AIRLINE LOUVERS

Vermont Agency of Transportation

SUBMITTAL REVIEW

Job Number: 57438

HEAD & SILL DETAIL

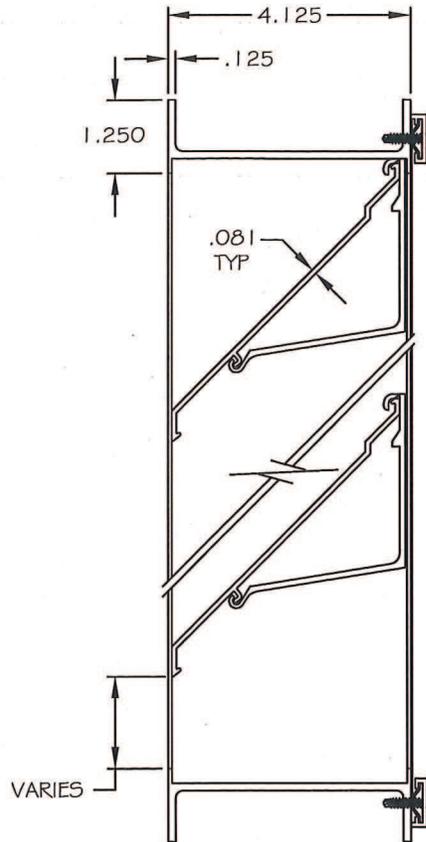
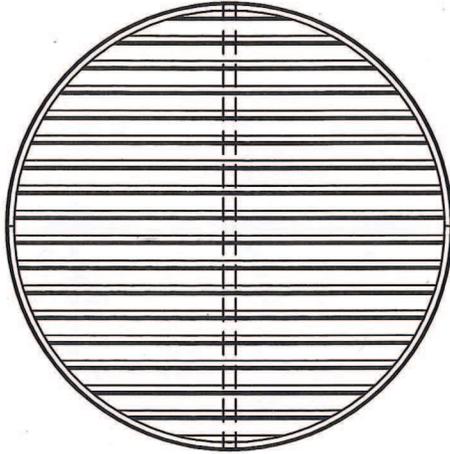
Incomplete
